## **NOTICE OF NON-PERFORMANCE**

On October 7, 2025, Energy Safety conducted an inspection of PacifiCorp's WMP initiatives in the vicinity of the city of Yreka, California. The inspection report is enclosed herewith. Energy Safety found the following deficiencies:

# INSPECTION REPORT

Structure ID: 20/7X

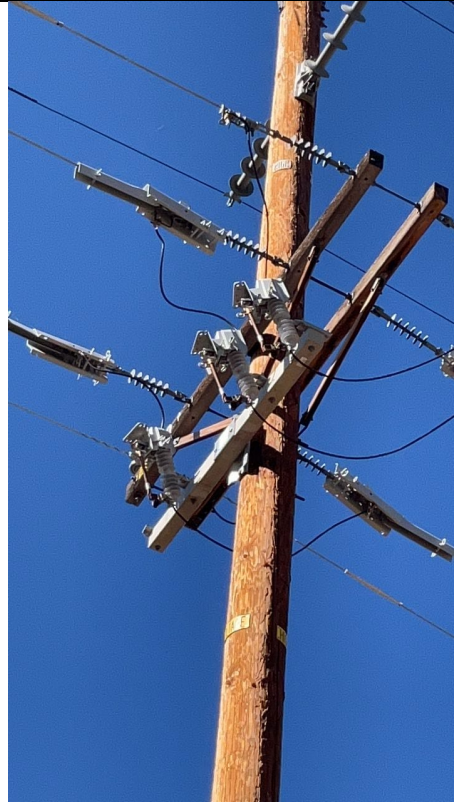
On Pole ID 20/7X, Grid Hardening ID 7112939 at 41.7383054840344, -122.615714, the inspector observed that CAL FIRE-approved non-expulsion fuses were not installed. The inspector's observation is documented in Deficiency 1 photographs, which are attachments to this report. Photo numbers IA1Img1, IA1Img2, IA1Img3, and IA1Img4 depict incomplete installation of CAL FIRE-approved non-expulsion fuses. In the 2025 Q2 Quarterly Data Report submission, PC reported that work on WMP initiative 8.1.2.12 – Expulsion Fuse Replacements were completed at this location.

1. CAL FIRE-approved non-expulsion fuses were not installed at the subject pole.
2. The inspector observed solid blade disconnects on the subject pole.
3. No reclosers, sectionalizers, or voltage regulators were observed at the subject pole.

Deficiency 1. Energy Safety observed that in implementing 2025 WMP initiative 8.1.2.12 – Expulsion Fuse Replacements, PC failed to complete the installation of CAL FIRE-approved non-expulsion fuses on pole ID 20/7X, Grid Hardening ID 7112939 at coordinates 41.7383054840344, -122.615714. Energy Safety considers this non-performance to be in the Minor risk category. PC must complete a corrective action for this deficiency by 12 months from the date of this notice.
